California Department of Transportation

July 16, 2024

SCH #: 2024060688
GTS #: 04-SCL-2017-01295
GTS ID: 7642
Co/Rt/Pm: SCL/152/R30.43

Re: Design Level Geotechnical Investigations for the Pacheco Reservoir Expansion Project – Mitigated Negative Declaration (MND)

Small Culverts (APR)

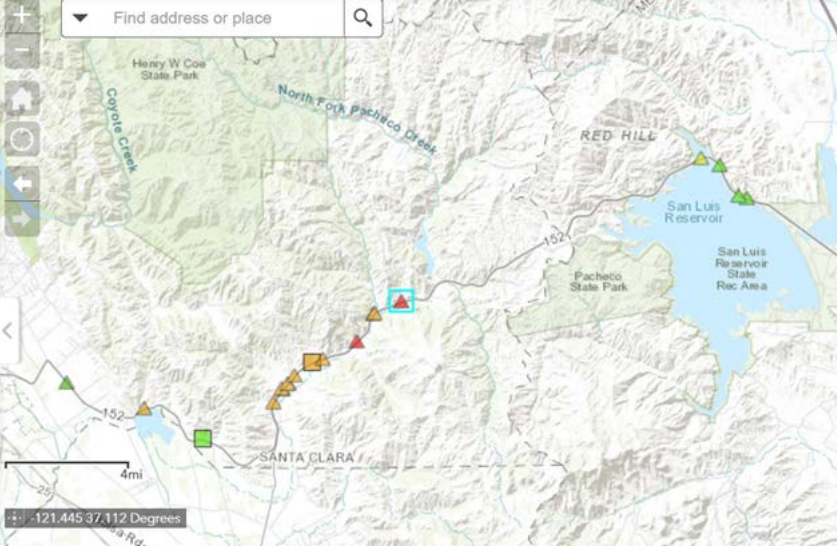
Please keep Caltrans informed about developments and implementations of various climate stressors, as well as ongoing adaptation and resilience initiatives at this project location near SR 152. A particular area of concern is the vulnerability to wildfires at this project location. Wildfires poses a significant risk along Caltrans' ROW, particularly affecting critical infrastructure such as culverts. Please see attached image of culverts around the project area.

The choice of culvert material determines susceptibility to direct wildfire damage. Culverts made from High-density polyethylene (HDPE), Polyvinyl Chloride (PVC), corrugated steel pipe, composite materials, and wood are more susceptible to wildfire damage. As a result, small culverts constructed from these materials, exposed to elevated wildfire risk, have been prioritized for adaptation measures.
